GREATER WASH TMZ AIRSPACE CHANGE

STAKEHOLDER CONSULTATION - FEEDBACK
Issue 2

Figure 2. Responses to each option

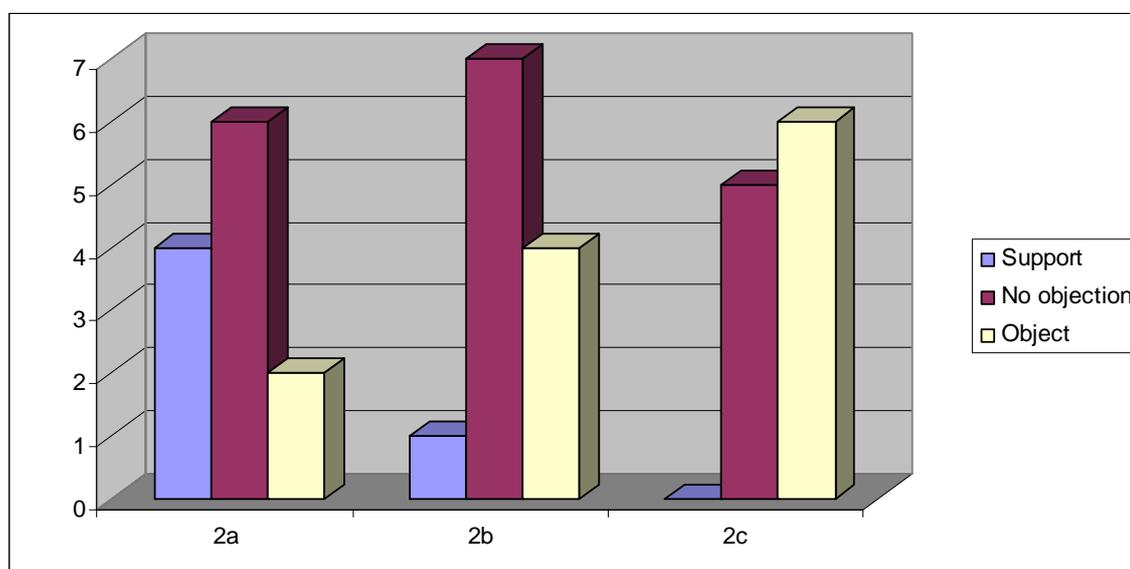
The responses (support /no objection /object) to each option are summarised in Figure 2. This shows that option 2c (5nm buffer) was not supported and had the highest number of objections. Options 2a & 2b were more popular, both receiving some support and a few objections. Option 2a being the smallest proposed TMZ received the most support.

Figure 3 TMZ with 2nm buffer around blanked areas (Airspace background)

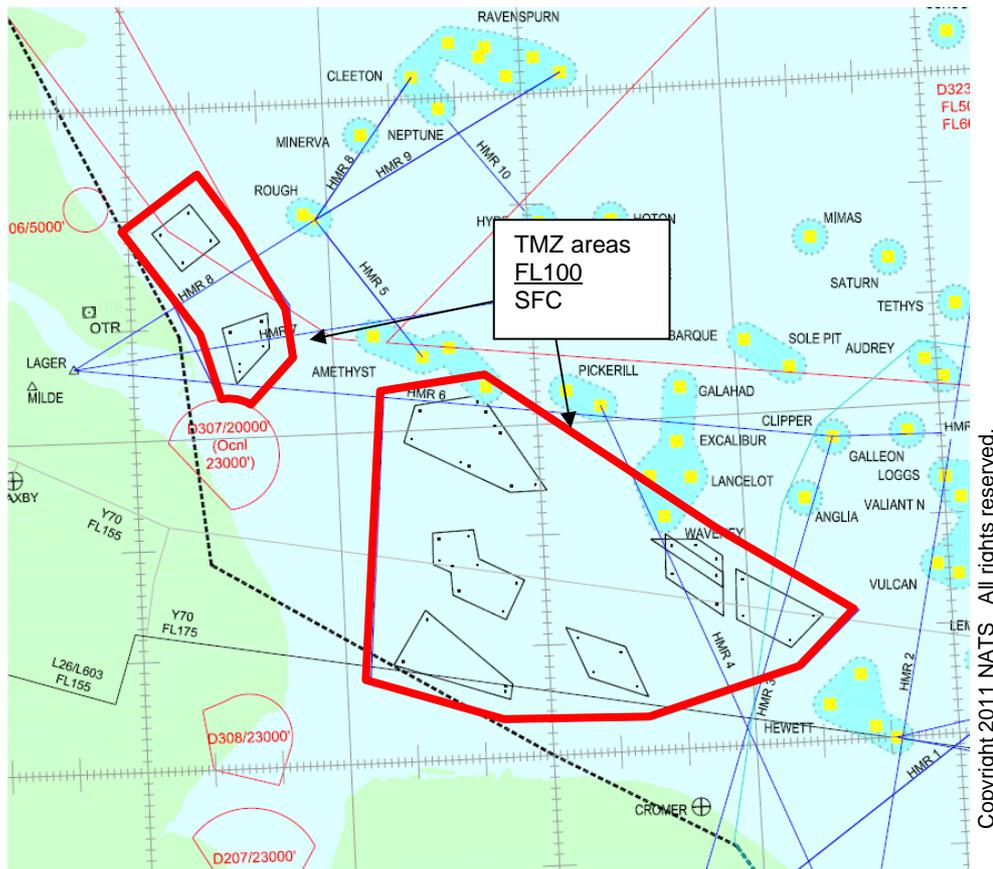
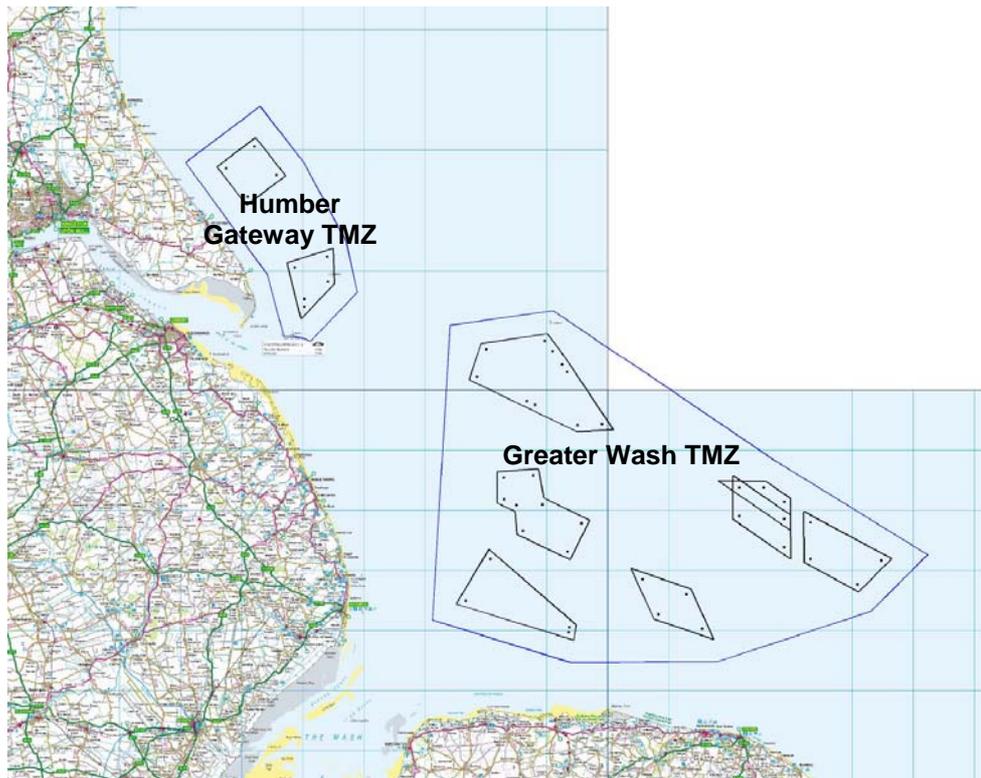
Option 2c in particular would have resulted in the TMZ extending beyond the coastline inland, and hence would have interfered with this practice for non-transponder equipped aircraft. Some stakeholders objected to option 2c on these grounds.

Option 2b will not impinge on the coastline and will leave at least 1.37nm between the coastline and the TMZ at its closest point. Non-transponder equipped aircraft will still be able to use the coastline as a navigational reference, and by following the coast they will automatically be keeping clear of the proposed TMZs.

As a result of careful consideration of all consultation responses, NATS will proceed with an airspace change proposal (ACP) to the CAA. The basis of this proposal will be for the introduction of 2 new TMZs as per Option 2b (2nm buffer), as shown in Figure 3. The proposed TMZ will extend from the surface to FL100. The TMZ with 2nm buffer strikes the best balance between the competing needs of the ATC requirement for a buffer around the blanked areas, and the GA community's desire for TMZs to be as small as practical, and not to impinge on the coastline.

This solution will allow non-transponder equipped GA aircraft to continue to fly along the coastline.

Figure 5 Changed areas

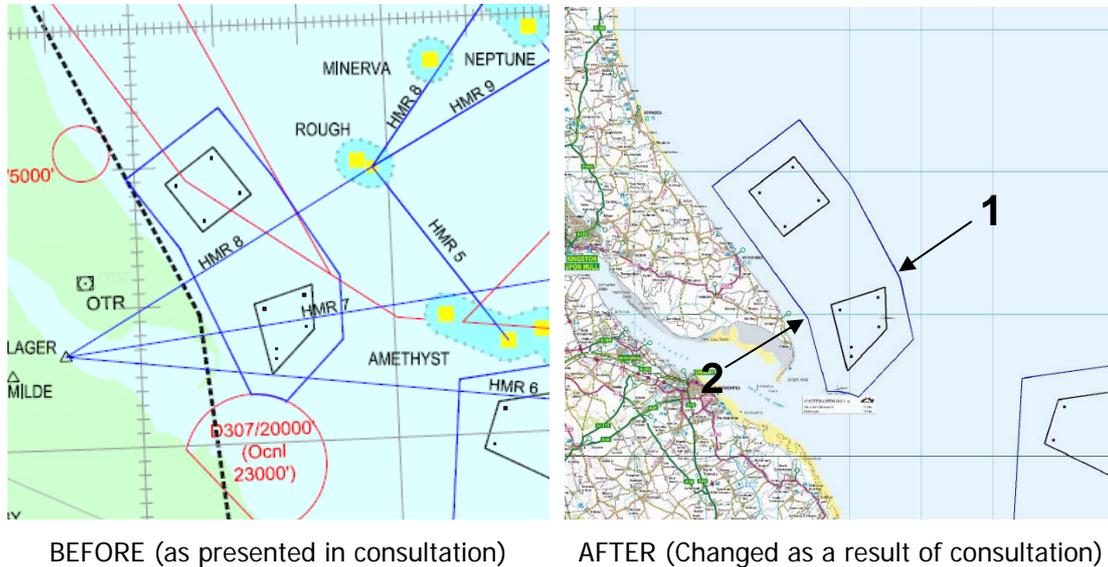
1. Following feedback from the MOD the NE edge of the Area 1 TMZ has been moved so that it is aligned with the boundary of D323B.
2. Following feedback from GA, the SW edge of the Area 1 TMZ has been moved to give a wider corridor for non-equipped VFR flights to fly along the coastline. Northbound VFR traffic will be able to follow the coastline observing 'ANO Rules of the Air Rule 16, Right-hand traffic rule'. At its closest point to the coast the TMZ is 2.53km (1.37nm) from the coastline.

3. The ceiling of the TMZ presented in the consultation was FL65. As a result of feedback this has been raised to FL100. If the ceiling were FL65, non-transponder equipped aircraft could over-fly the TMZ (e.g. at FL70). In this case ATC would observe a primary return with no altitude information entering the TMZ. Hence if providing a deconfliction service they would have to assume that this aircraft was infringing the TMZ and would attempt to provide 5 miles separation from the return, for traffic receiving a service. Above FL100 transponder

carriage is mandatory². Hence if the TMZ extends up to FL100, over-flight of the TMZ by non equipped aircraft would not be permitted. The consultation was extended to allow further feedback to be solicited on the raising of the ceiling to FL100, since this option was not presented at the outset of consultation. Of the 13 respondents to the first round consultation, 77% responded to the extended consultation. There were no objections to the proposal for the TMZ ceiling to be FL100.
